SERVICE BULLETIN # 1038

SUBJECT NEW OIL PUMP SPRING

MODEL **MAC35A** S33, 33B, 35, 39 and Mac 35

DATE 10/30/58

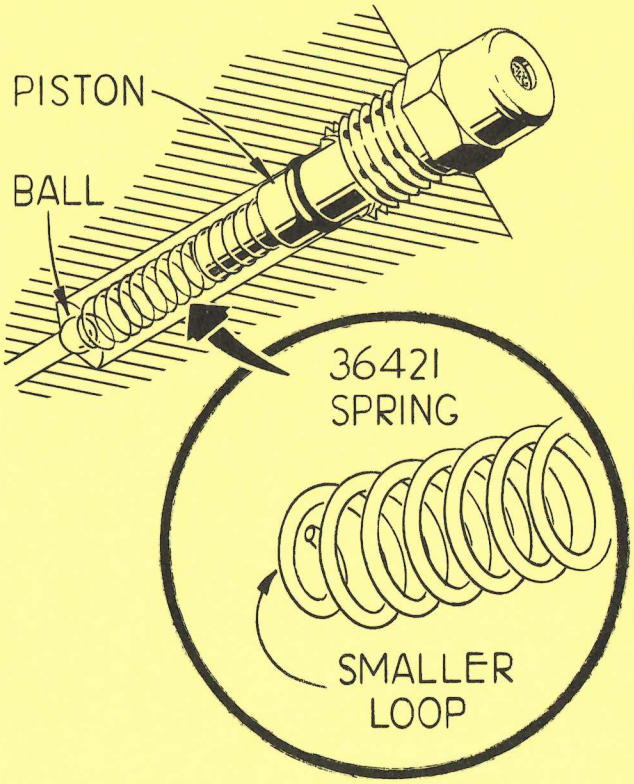
A new oil-pump piston-return spring, P/N 36421, is now installed on Mac 35A engines. This new spring eliminates the need for the check-valve ball-retainer, P/N 36161, which was used with the earlier piston return spring, P/N 19236, in all 33 Series saws previous to the Mac 35A.

The last coil on the check-ball end of this new spring is formed into a smaller loop which firmly holds the check-ball on its seat. When assembling the new spring into the oil pump chamber in earlier 33 Series saws, special care should be taken to have the smaller coil flat so that it exerts direct pressure against the ball on its seat.

Particular care should also be taken to have the upper end of the spring fit freely over the pump piston, P/N 36126, so that the return action of the piston will not be restricted.
